SCOPE OF PROJECT CHANGES:

PERMIT DRAWINGS

CLARKSON RESIDENCE

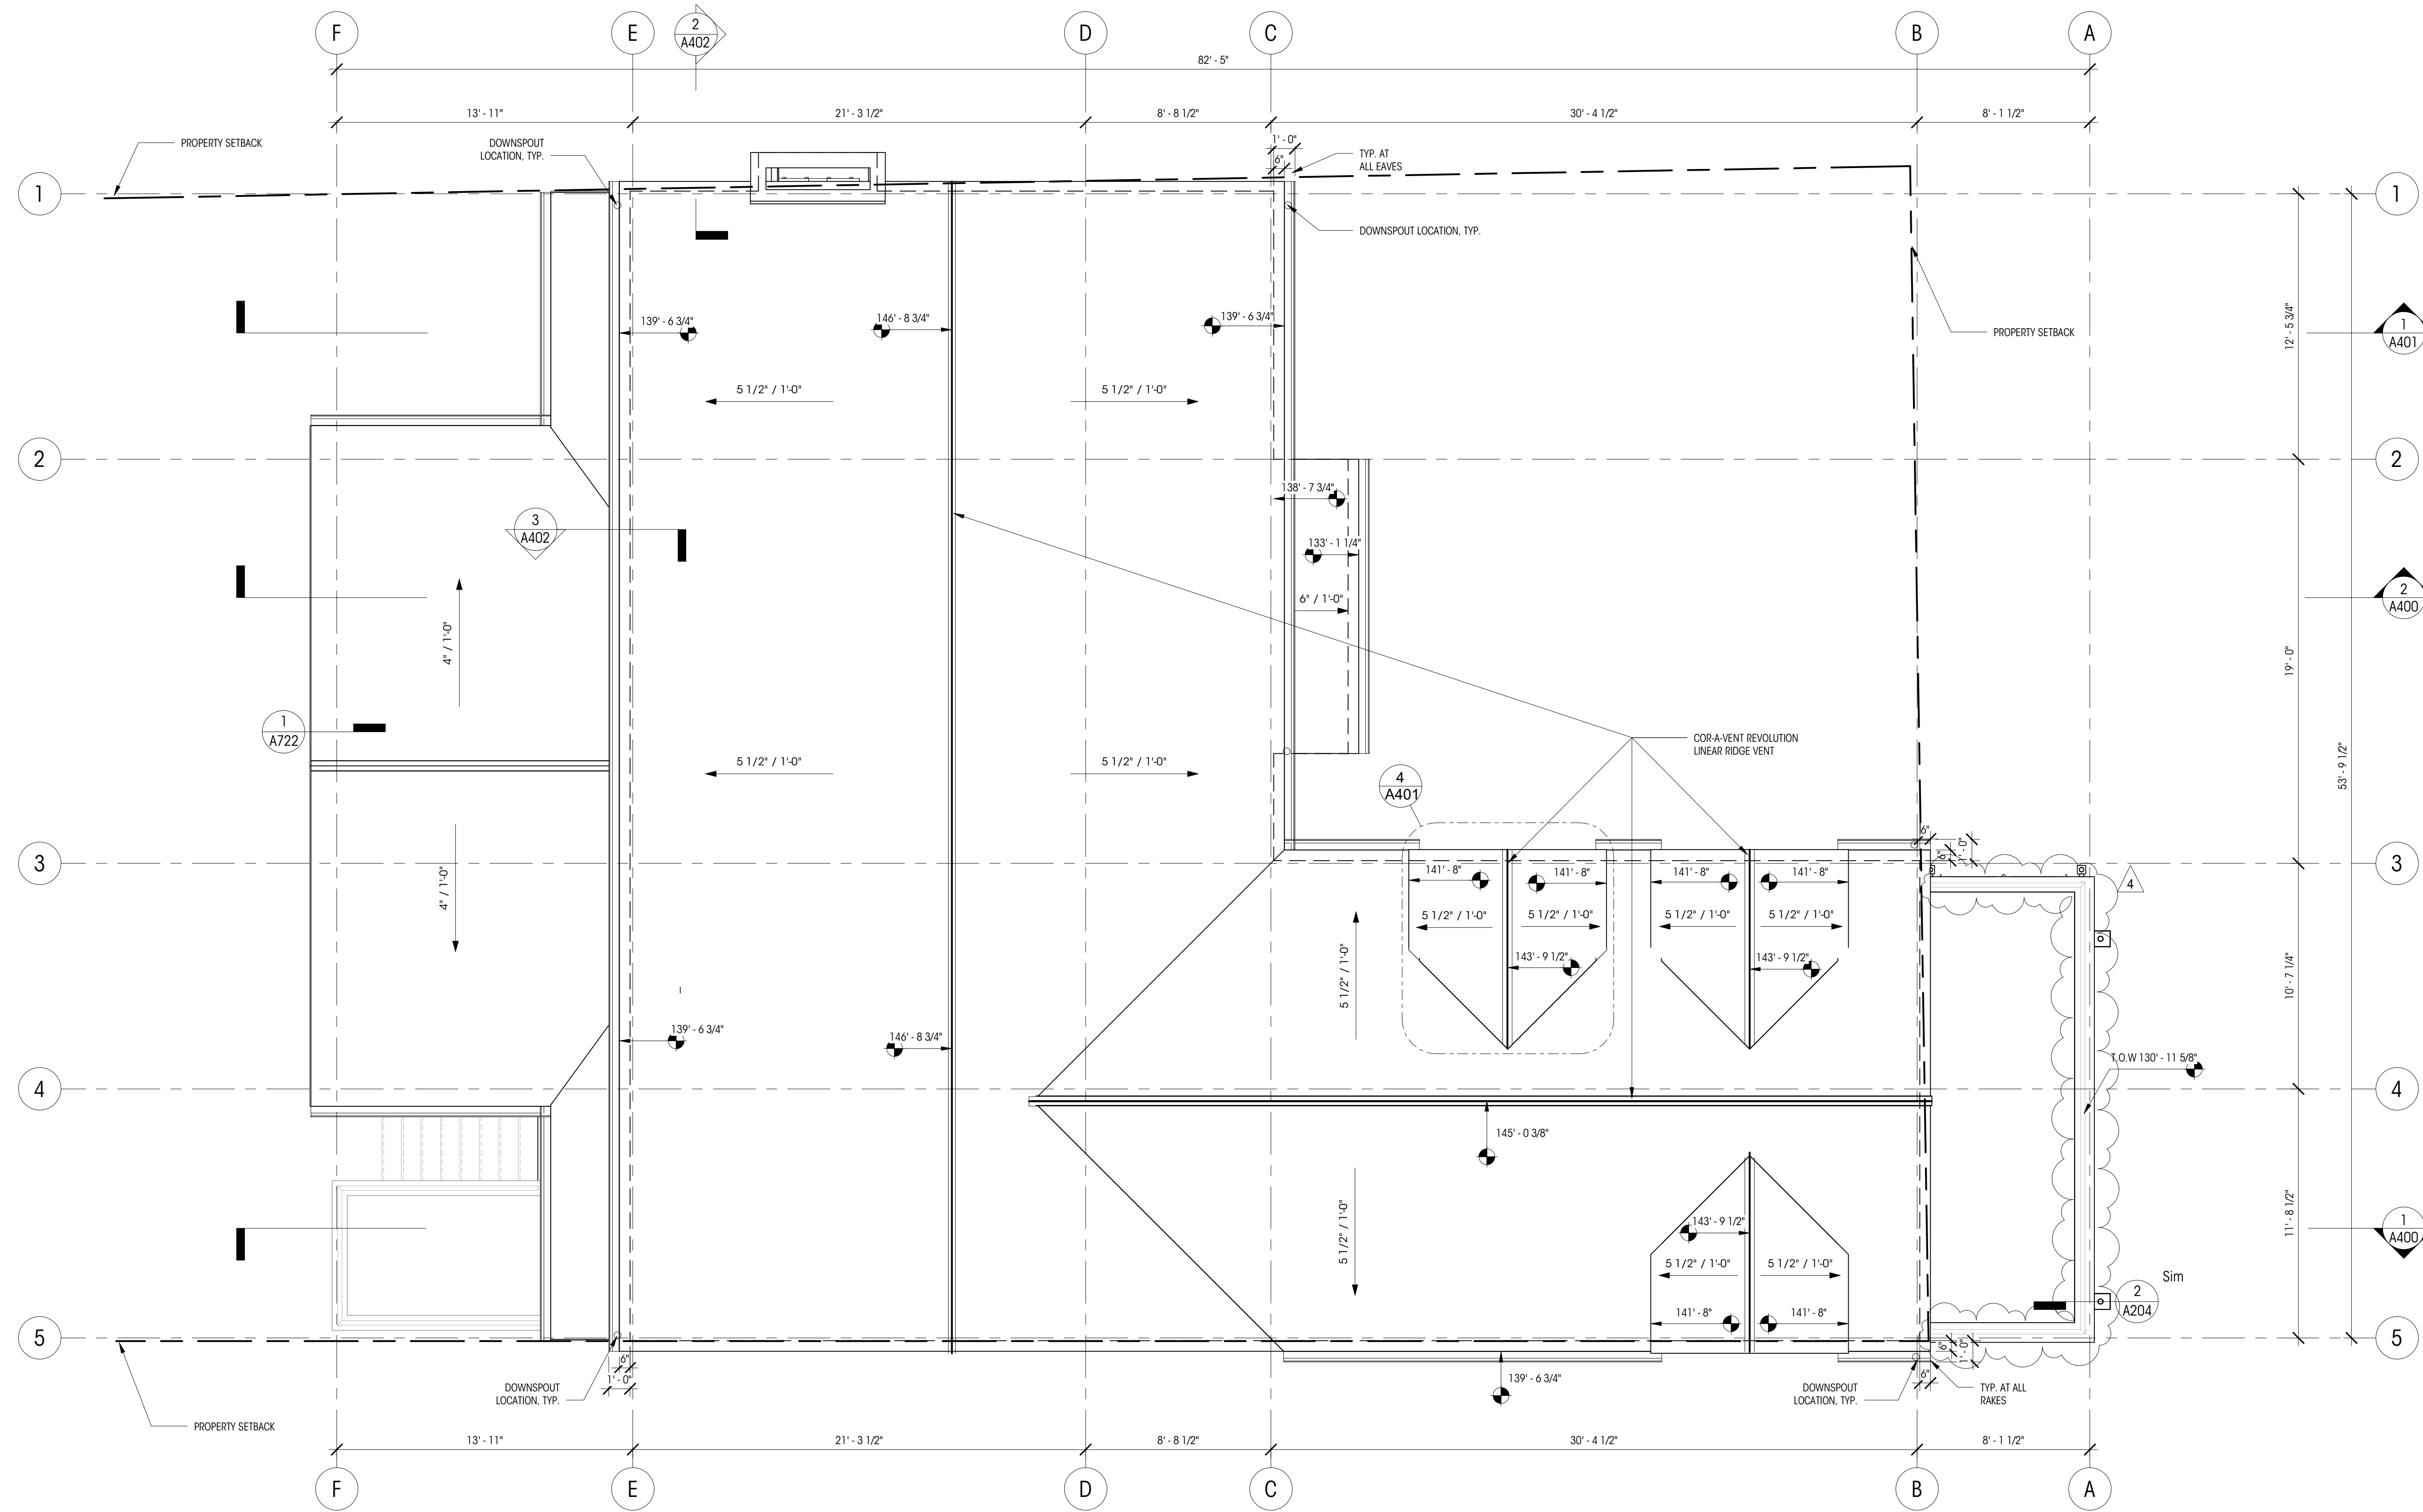
- CHANGE ROOF OF AND EXTEND WESTERN PATIO TO THE WEST AND SOUTH
- ADDED DORMERS AT UPPER LEVEL BONUS ROOM
- ADDED DECK AT ROOF OF THE EXTENDED GARAGE AREA.
- ADDED DETAIL FOR EXTENDED DECK DRAINAGE
- UPDATED ROOF VENTING CALCS AS A RESULT OF DORMER ADDITION
- REDUCED ROOF PITCH FROM 6:12 TO 5.5:12.

1 PROPOSED NORTH ELEVATION
1/4" = 1'-0"

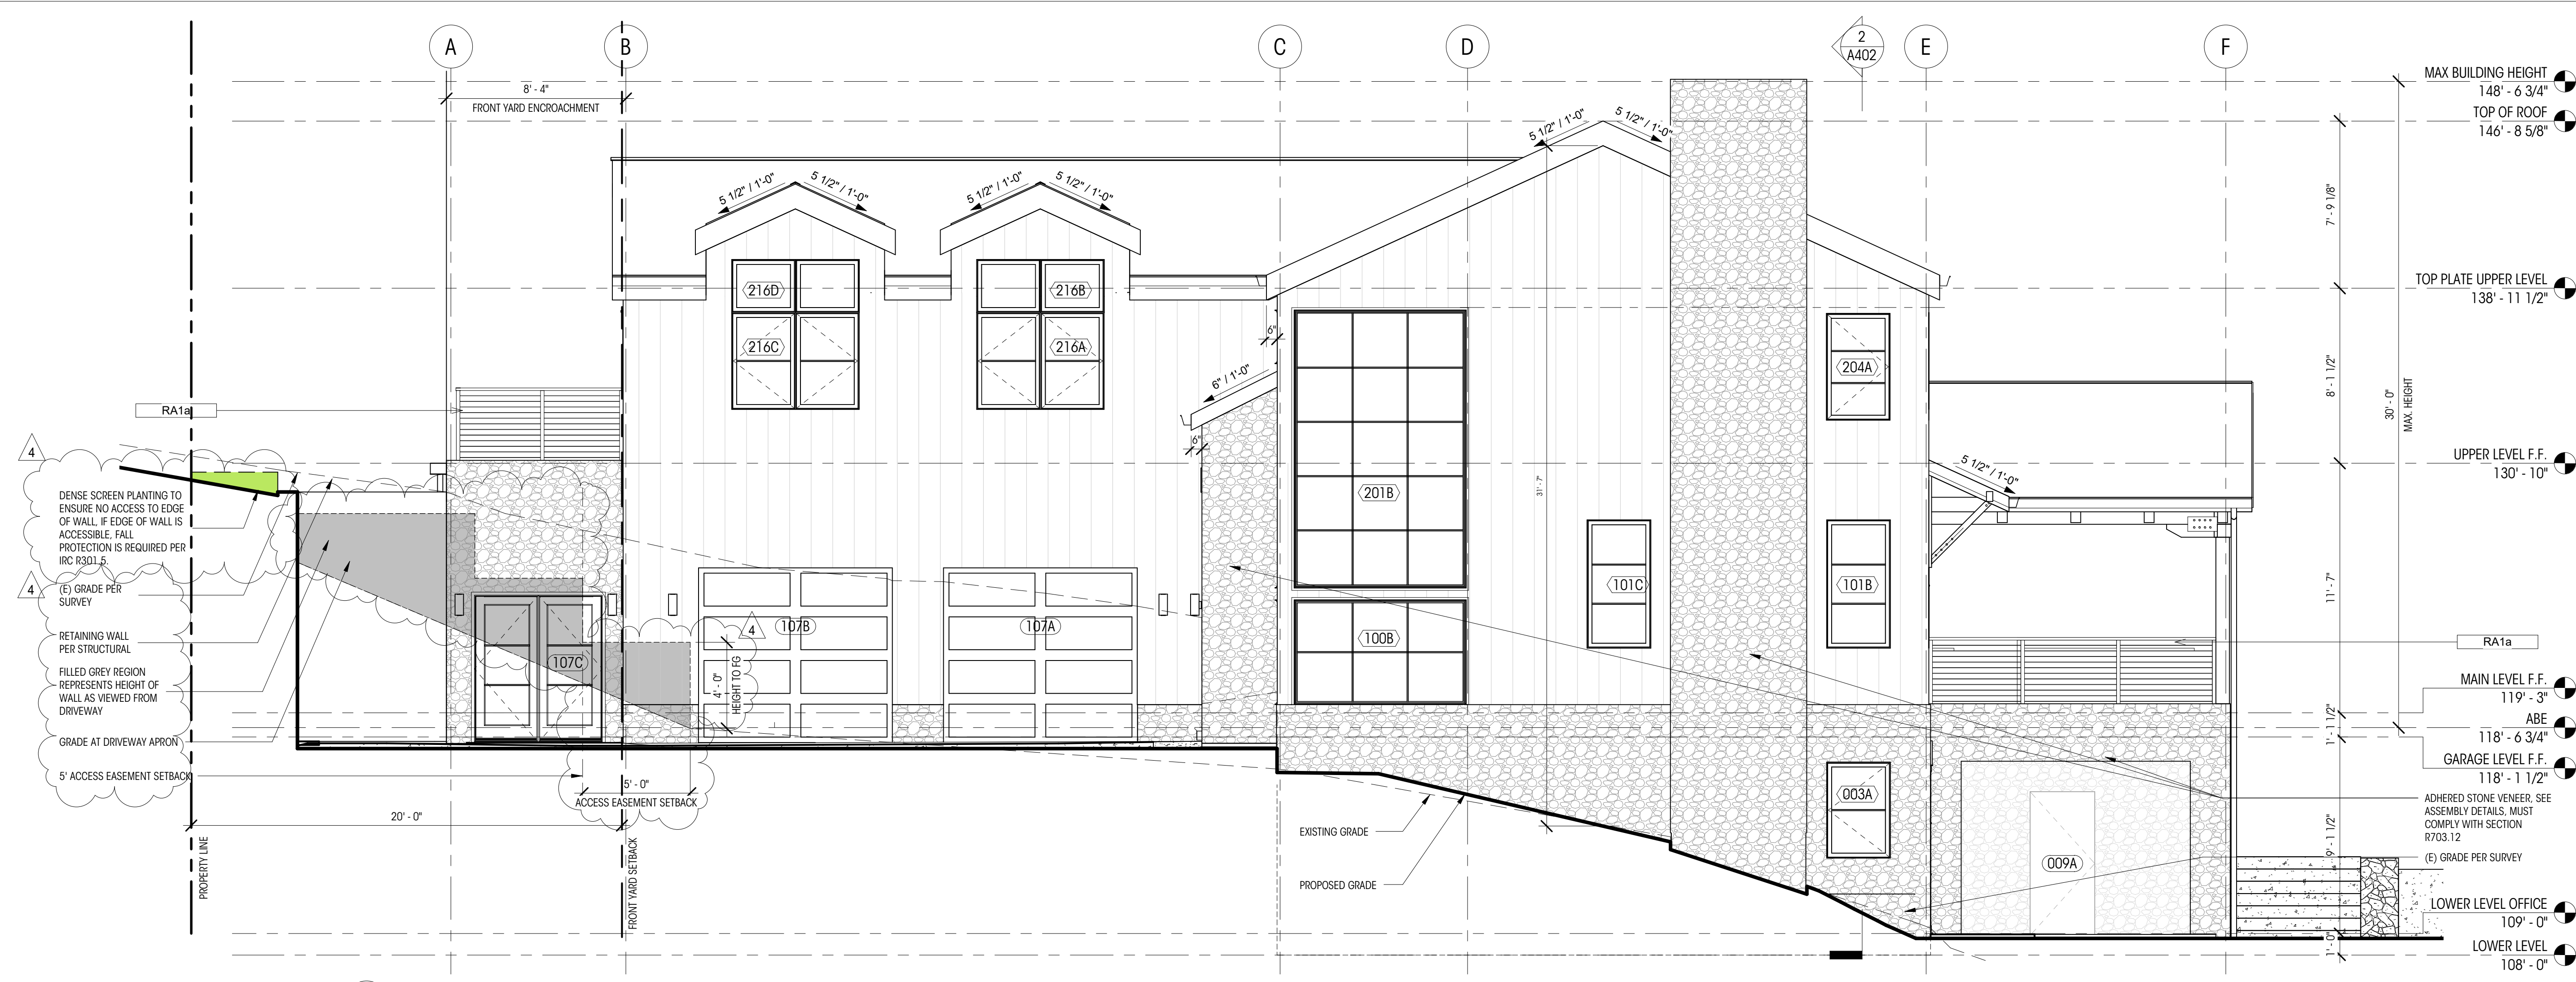
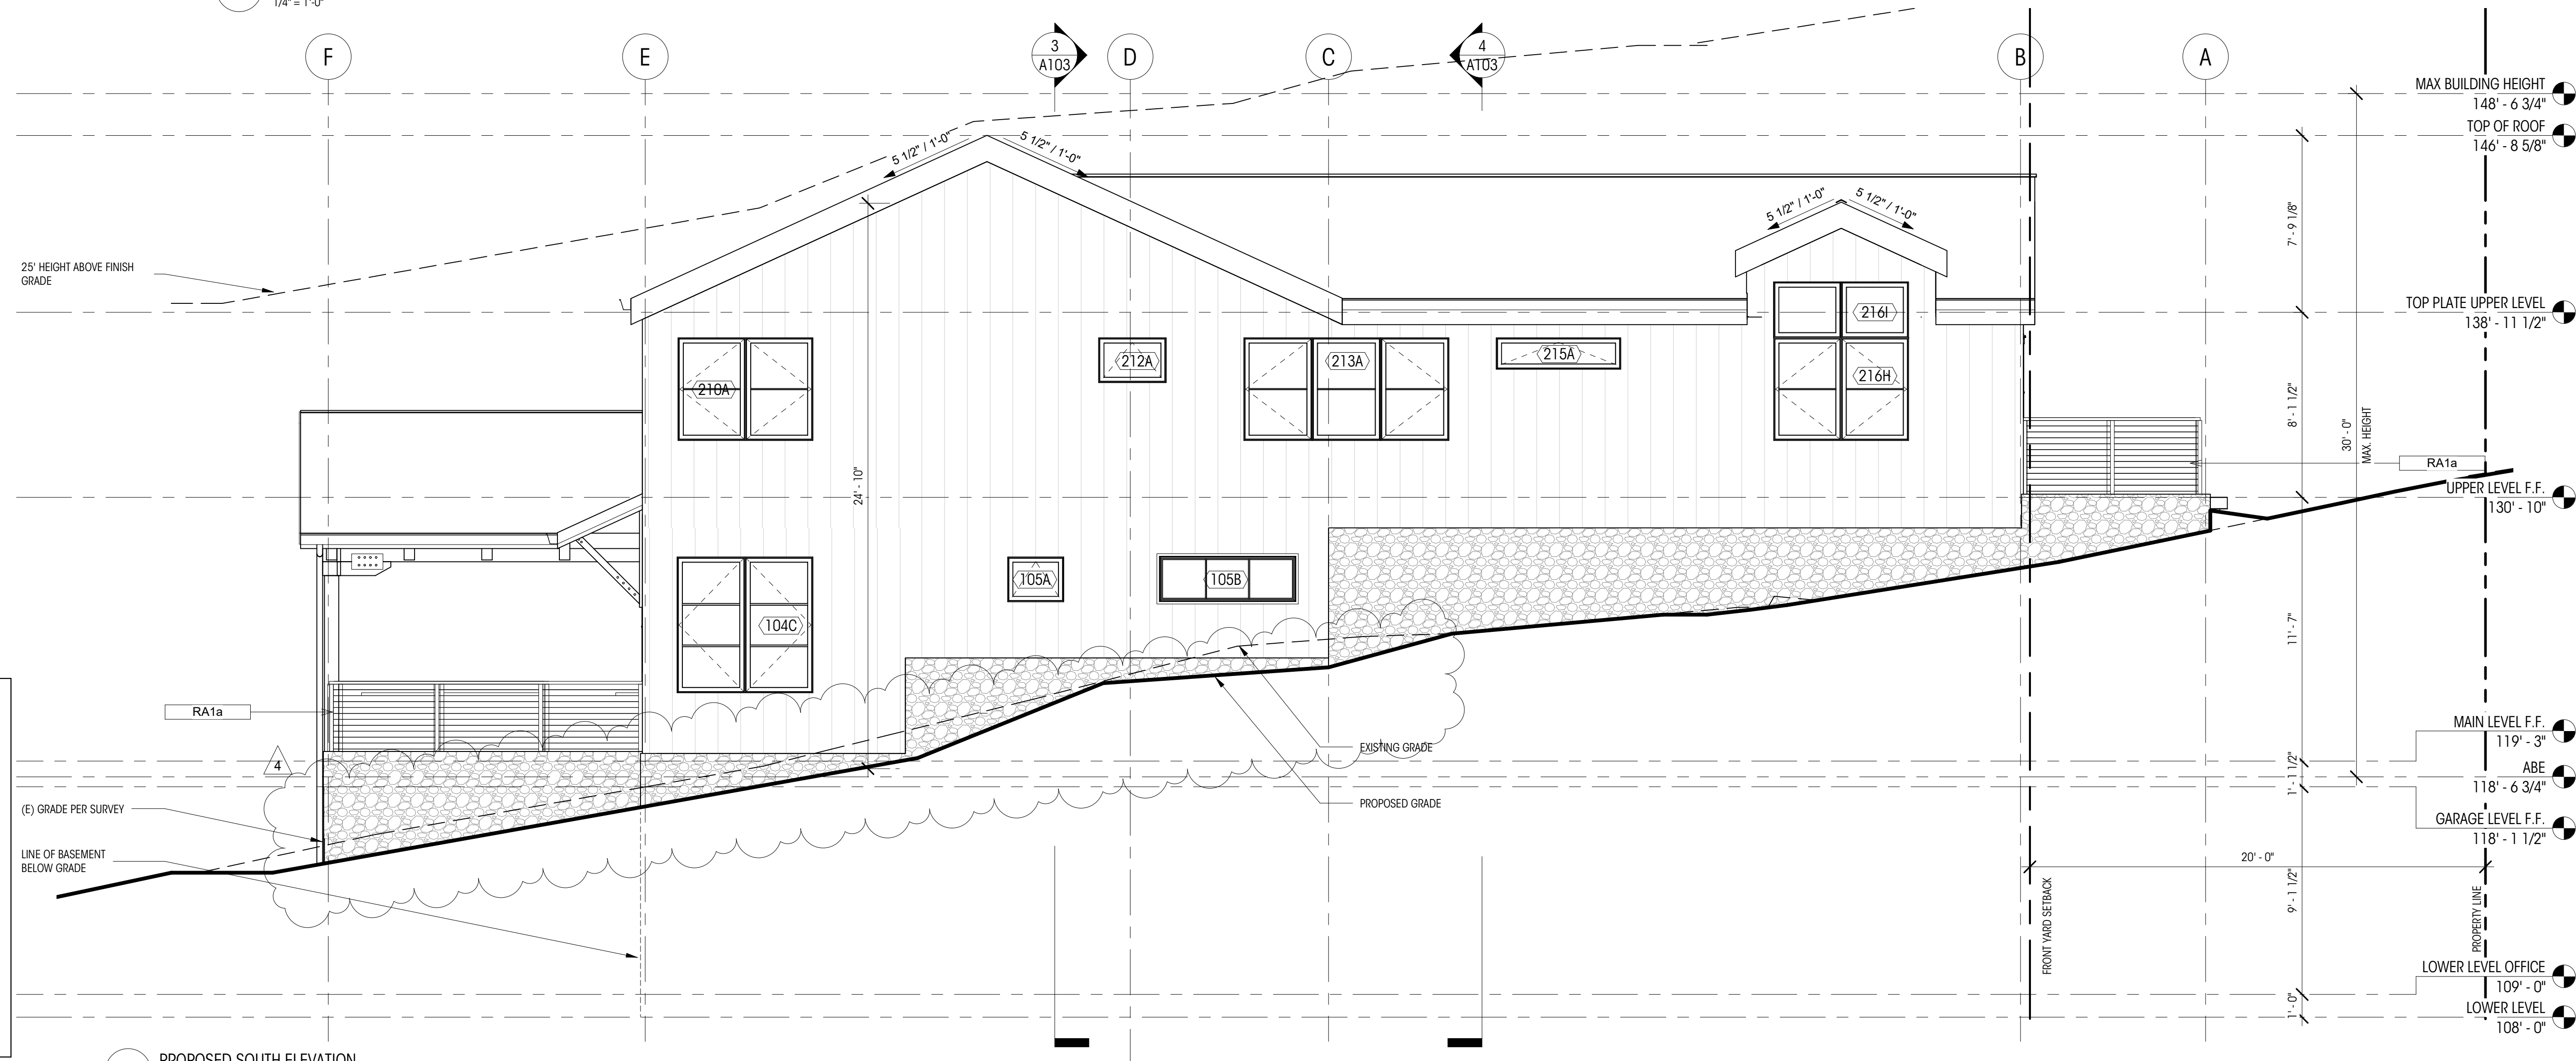
- CHANGE ROOF OF AND EXTEND WESTERN PATIO TO THE WEST AND SOUTH
- ADDED DORMERS AT UPPER LEVEL BONUS ROOM
- EXTEND GARAGE EAST INTO FRONT YARD SETBACK AS ALLOWED BY CODE 19.02.040.D
- WINDOW SIZE & LOCATION CHANGES
- LEVEL CHANGES:
 - a. DRIVEWAY & GARAGE LEVEL DROP BY 15"
 - b. BASEMENT LEVEL DROP BY 12"
 - c. UPPER LEVEL DROP BY 2"
 - d. FRAMED FLOOR 12" ABOVE BASEMENT FLOOR.
 - e. CHANGE TO ABE AS A RESULT OF EXTENDED GARAGE AND EXTENDED COVERED DECK
 - f. CHANGE TO MAX HEIGHT AS A RESULT OF THE ADJUSTMENT TO THE ABE.
 - g. TOP PLATE LEVEL ADJUSTED UP BASED ON ROOF FRAMING
 - h. ROOF OF ROOF HAS LOWERED AS A RESULT OF REDUCED ROOF PITCH
- SITE WALL MATERIAL CHANGE
- UPDATED STEPPING FOUNDATION WALL PROFILE TO MATCH STRUCTURAL
